May 23, 2013

**ADDENDUM NO. 1
TO THE
INVITATION TO BID(ITB) - 4293
FOREST AVENUE IMPROVEMENT PROJECT
FOR THE
CITY OF ANN ARBOR, MICHIGAN**

The following changes, additions, and/or deletions shall be made to the Bid Documents for the Forest Avenue Improvement Project, for the City of Ann Arbor, Michigan, Invitation To Bid No. ITB - 4293.

DETOUR PLAN

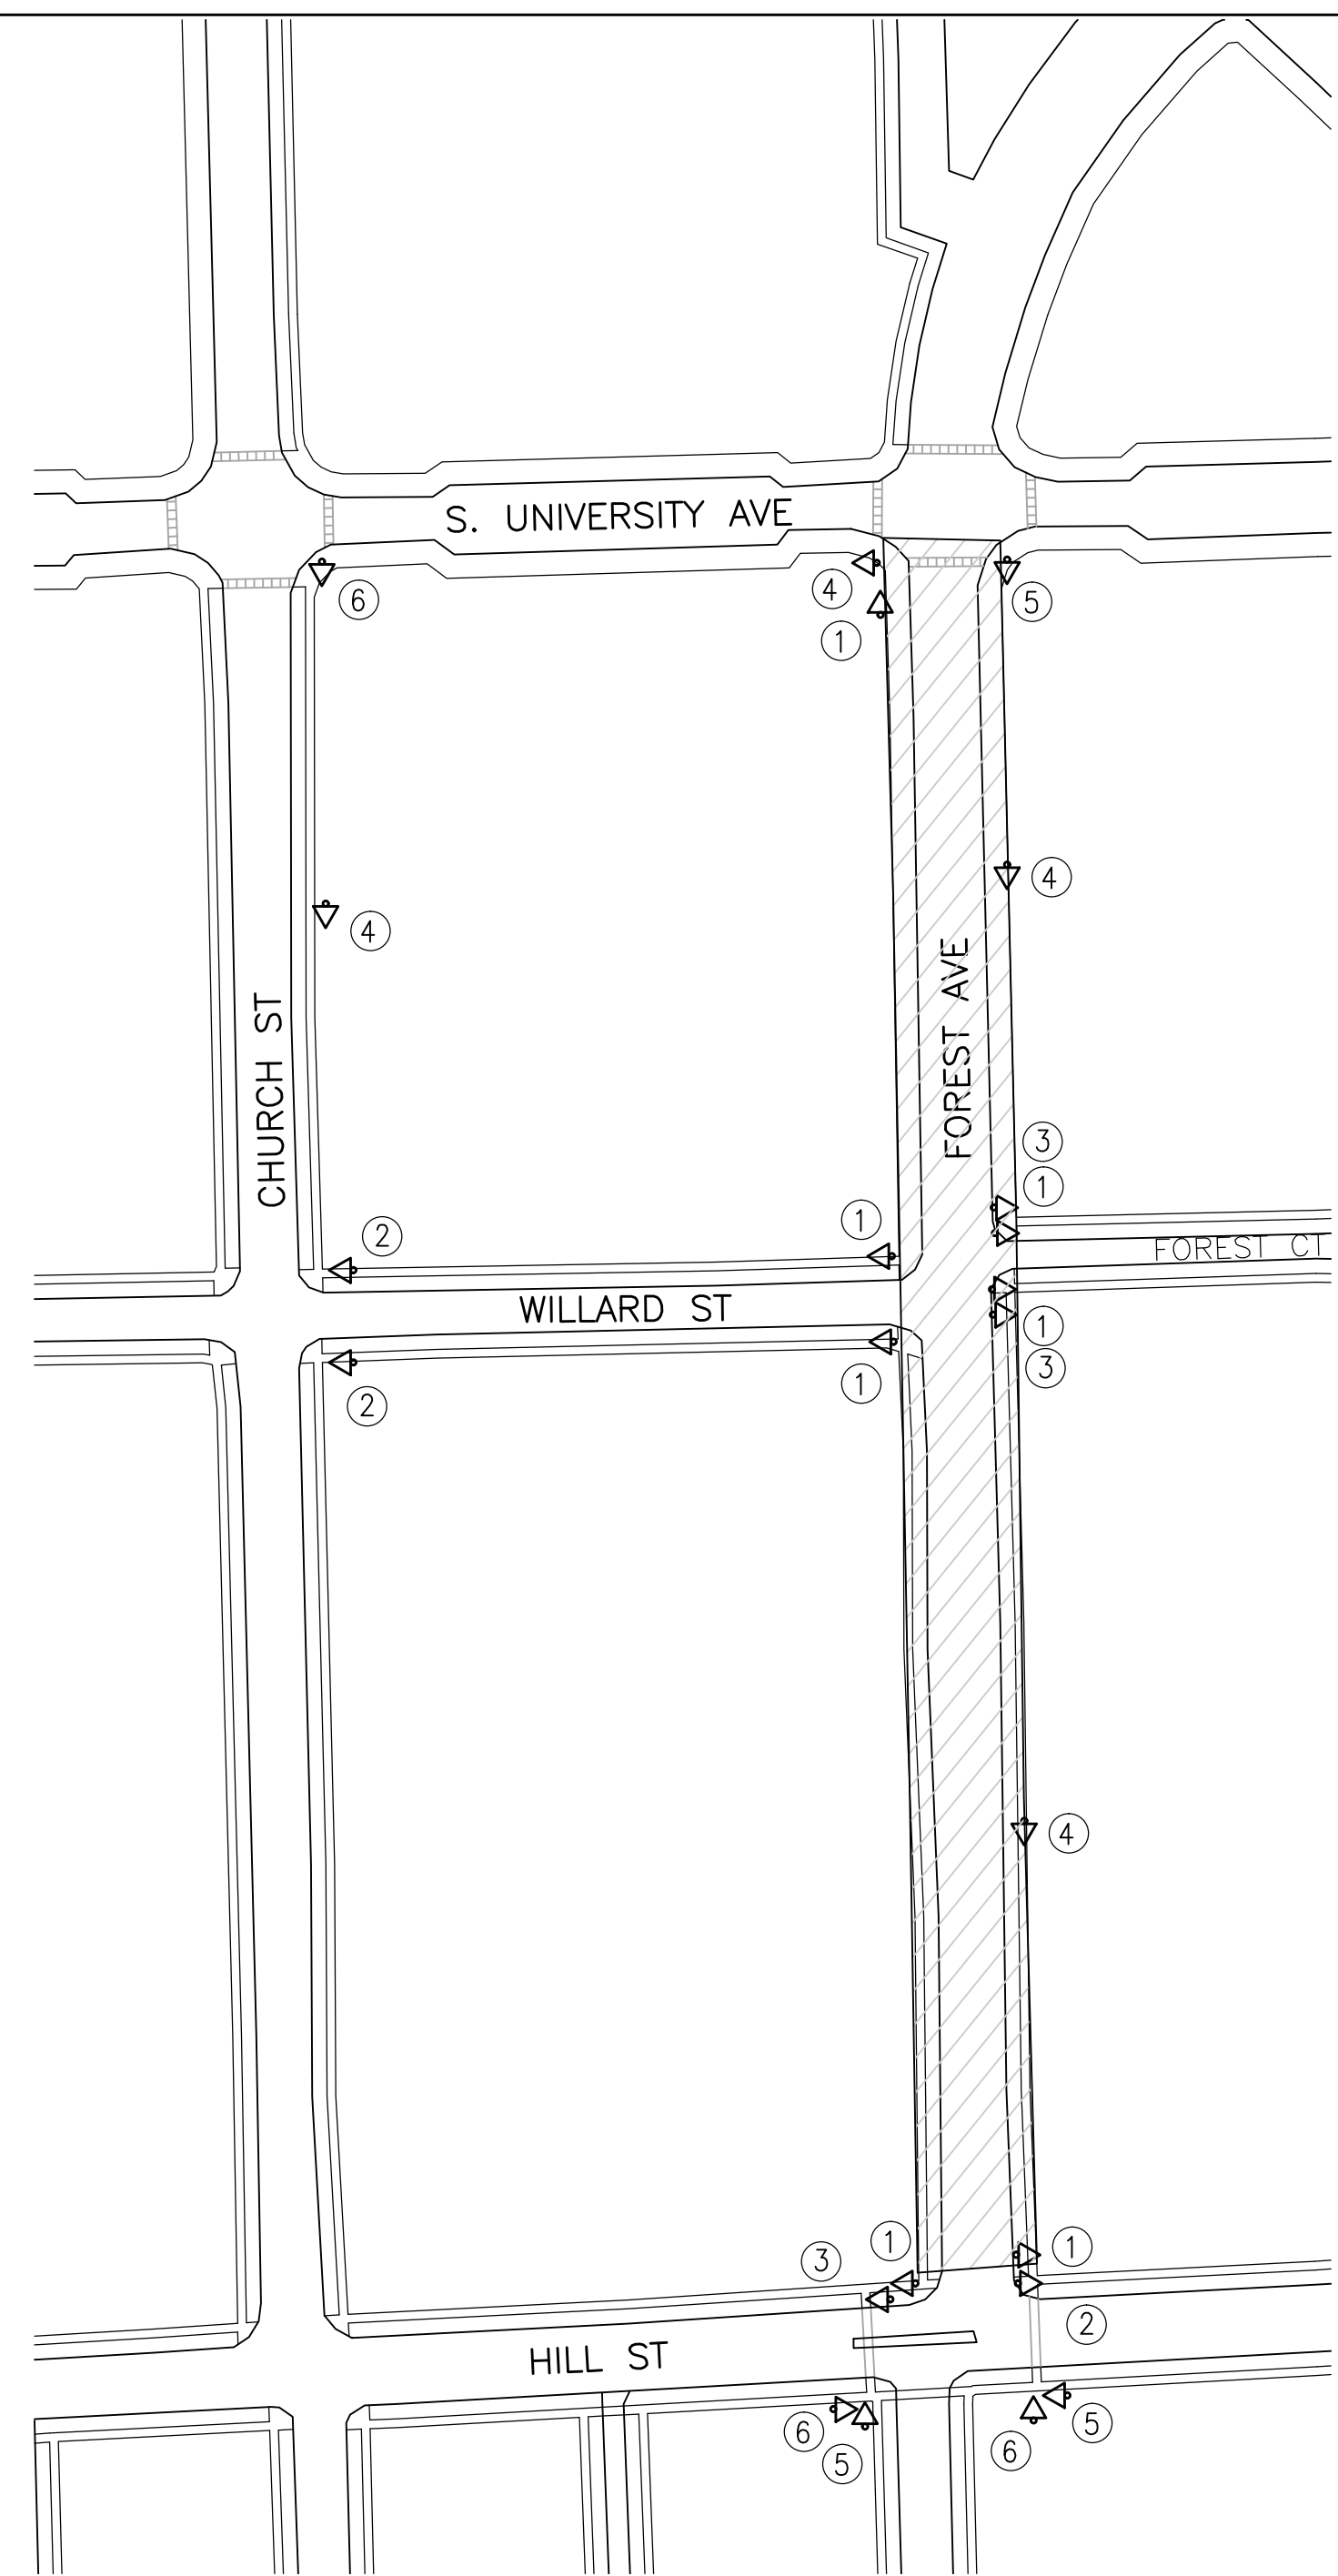
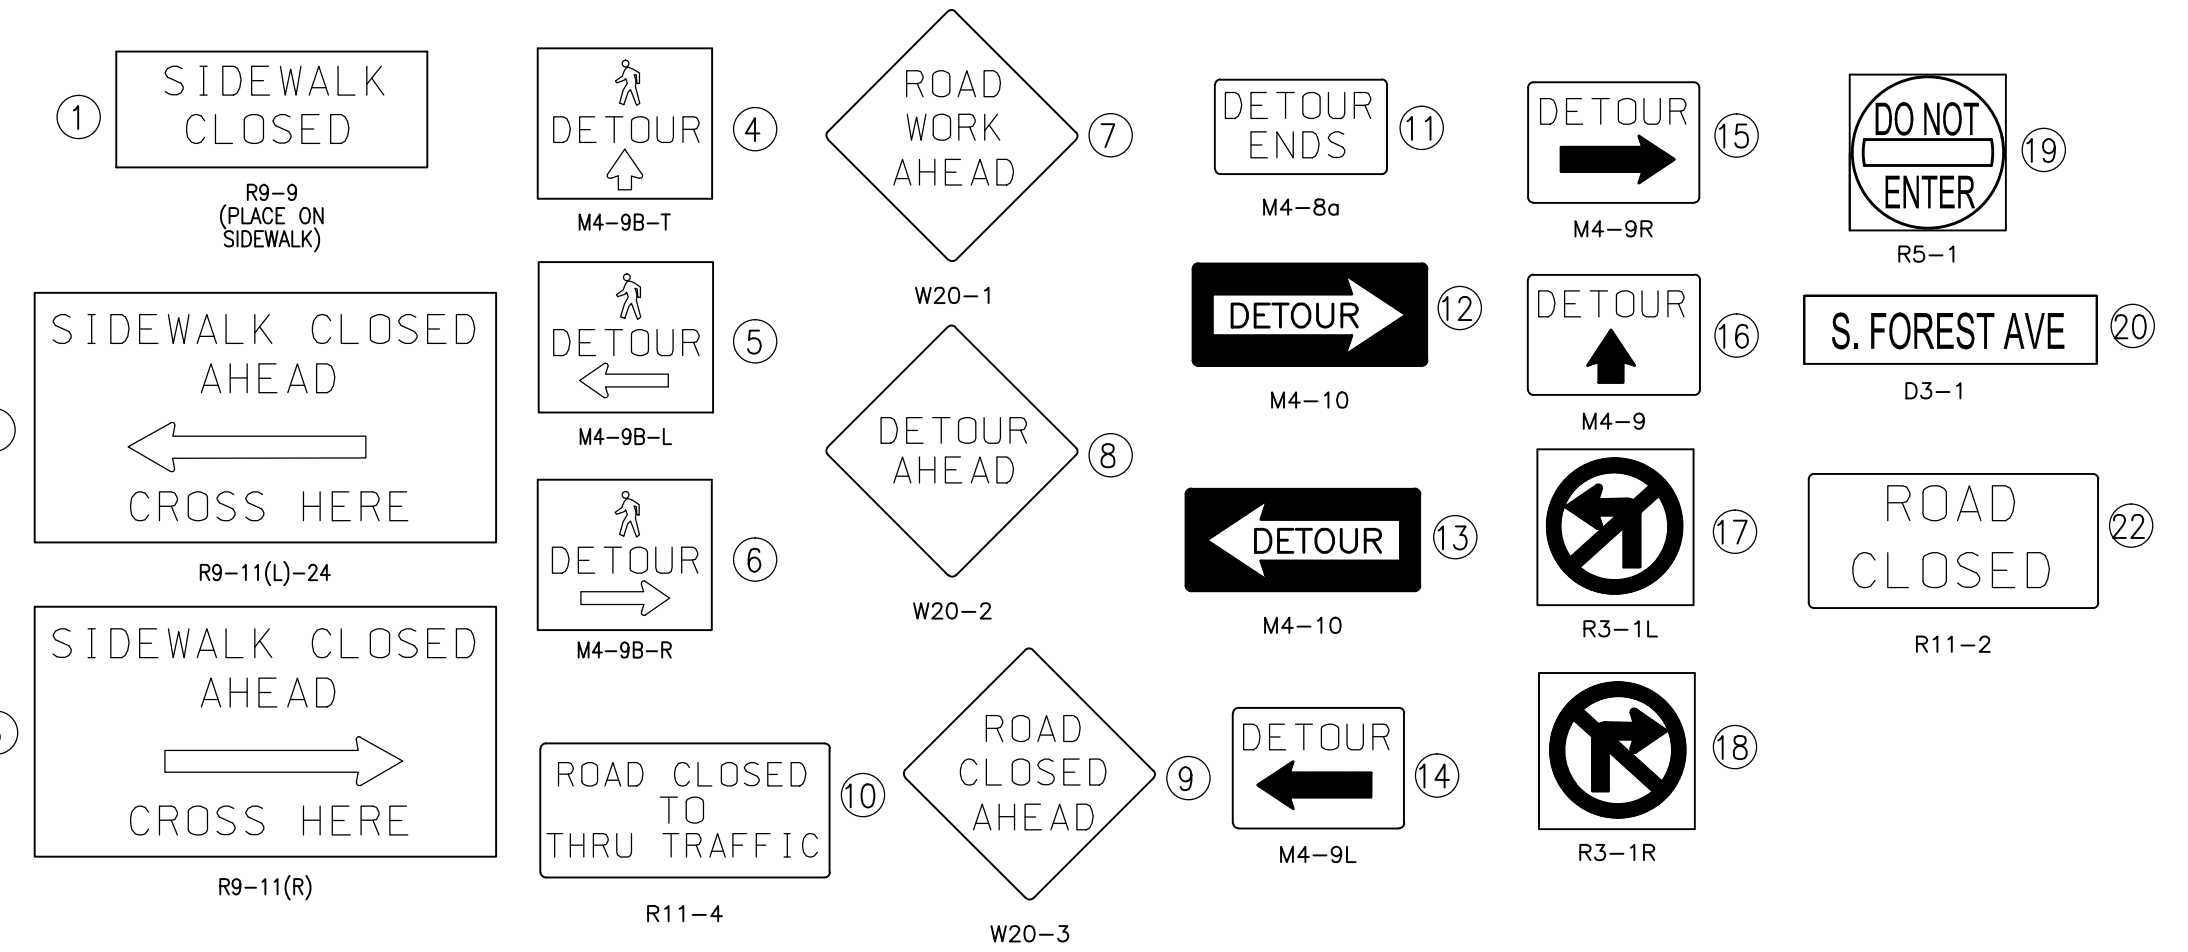
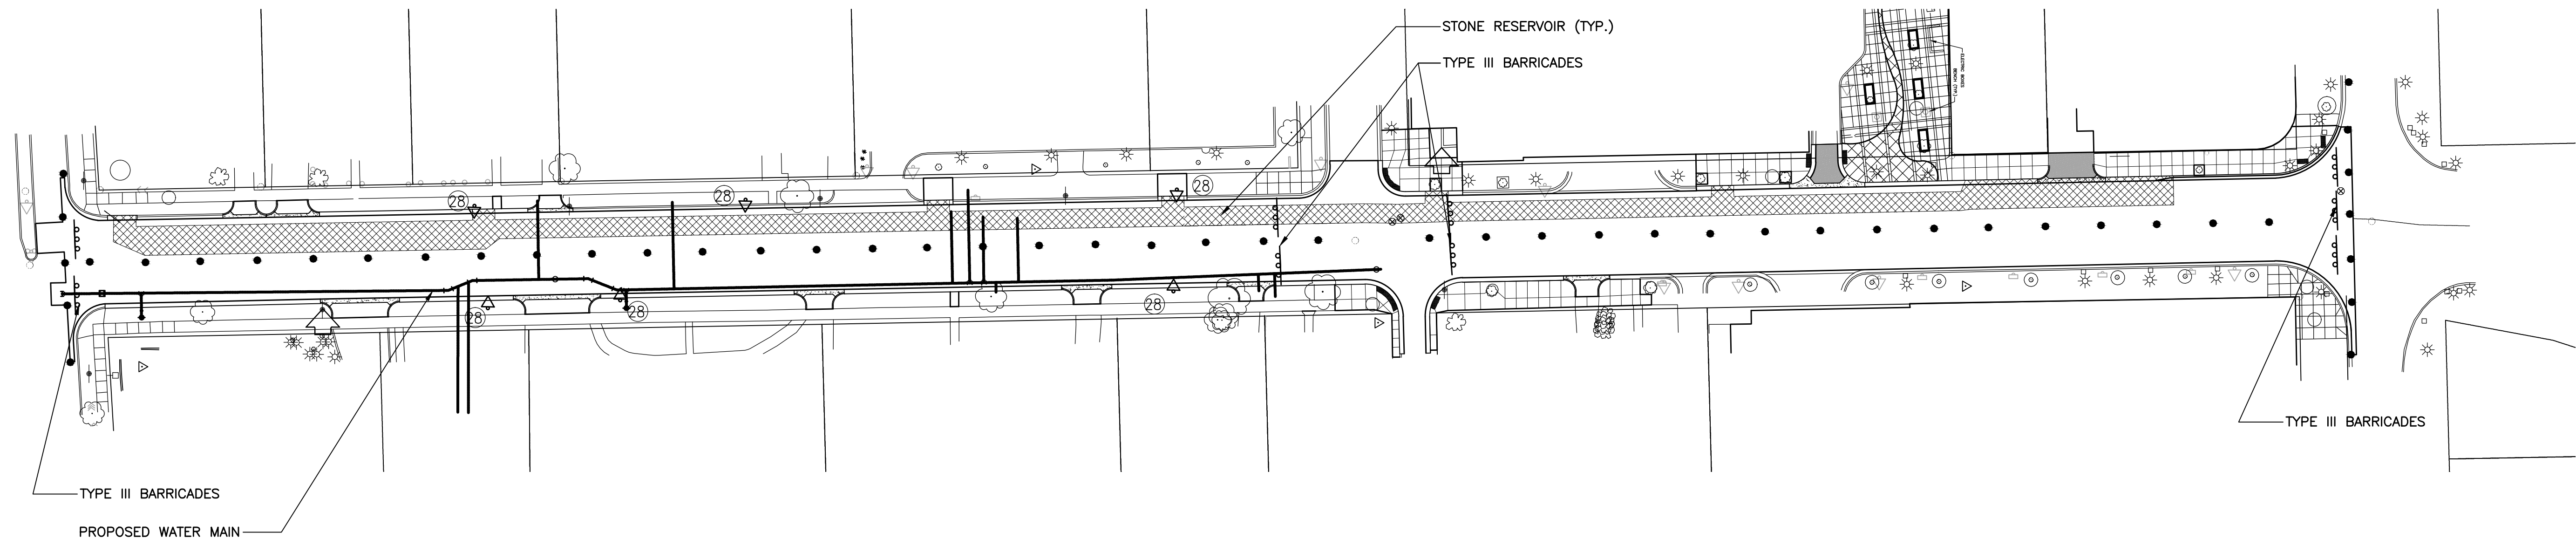
- Item #1: Contract Documents, BF-1 through BF-3;
Replace pages BF-1 through BF-3 with the attached revised BF-1(ADD-1-2) through BF-3(ADD-1-4).
- Item #2: Contract Documents, Detailed Specification:
Replace pages DS -4, DS - 8, DS - 18, DS - 19, DS - 40, DS - 43, DS - 53, DS - 54, DS - 55, DS - 57, DS - 58, and DS - 59 with the attached revised pages ADD - 1-5 through ADD -1-16
- Item #3: Contract Plan Set; replace plan sheets 10, 11, 12, 15 and 16 with attached plan sheets.
The revised plans show changes to the Traffic Control and Transformer Park reconstruction.

REV.	DATE	DESCRIPTION
01	05-08-2013	BID SET
02	05-22-2013	ADDENDUM #1 - ENTIRE SHEET
		CEW
		CEW
		ATP
		ATP
		DRAWN
		CHECKED
